**Technical Service Bulletin:** TSB190042

**New Vented Coolant Drain Line Kit to Reduce Variable Geometry Turbocharger Actuator Overheating: FC2636 and FC1894**

Figure 1, Coolant Vent Line Routing. OEM Top Tank (1). VGT Actuator (2).

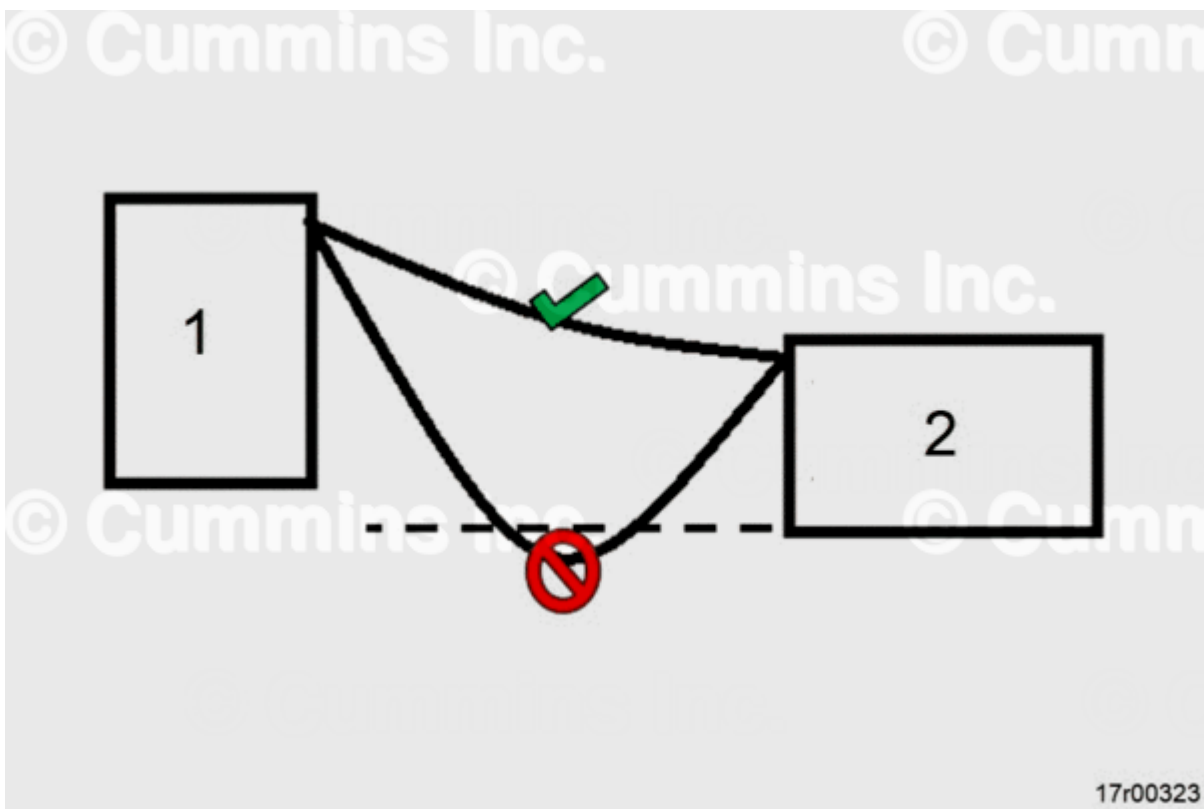
- New turbocharger actuator vented coolant drain line kits are available with a horizontal or vertical outlet.
- Turbocharger actuator vented coolant drain line orientation **must** be determined in order to determine correct service kit to be ordered. See Figures 1, 2, 3, and 4 for existing product and service kit layouts.
- See Figure 5 for new production routing.
- See Table 1 for kit part numbers.
- For new turbocharger actuator coolant drain line kit installation, see corresponding Service Manual. Reference Procedure 008-017 in Section 08.
- Dips or sags of the coolant vent line below the bottom surface of the actuator should be avoided. If the coolant vent line to the OEM top tank, dips or sags below the bottom surface of the turbocharger actuator, the coolant vent line **must** be shortened and raised to be above the top surface of the turbocharger actuator. See Figure 1 below.

Figure 6, Existing Production Turbocharger Actuator Coolant Drain Tube With Vent Accommodation (Left), Part Number 5302803. New Production Turbocharger Actuator Coolant Drain Tube with Vent Accommodation (Right), Part Number 5446929.

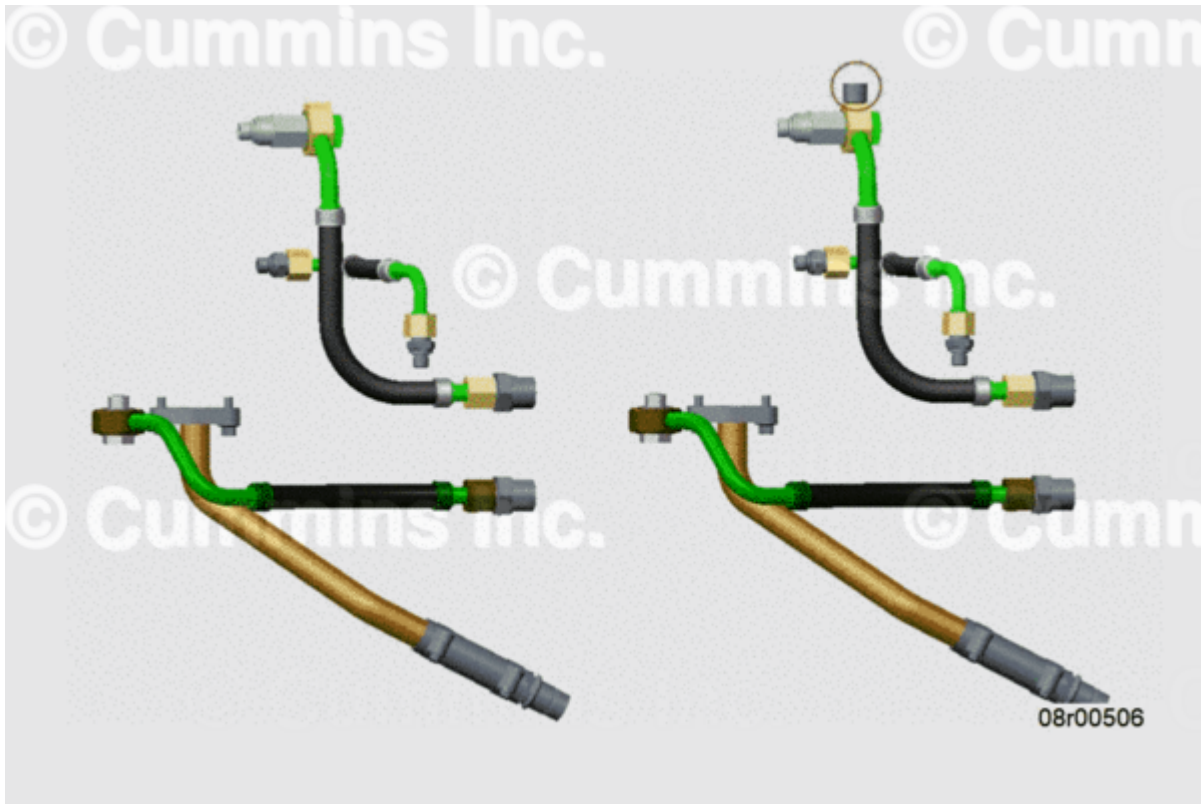
A Plain Pipe Coupler is required at the EGR coolant out vent location to install the new turbocharger vent lines. See Figure 6 for example of EGR vent line installed with the necessary plain pipe coupler. See Figure 7 for example of EGR cooler vent line installed without Plain Pipe Coupler. If engine does **not** have the plain pipe coupler installed see Table 3 for additional part number to order to install new turbocharger vent lines.
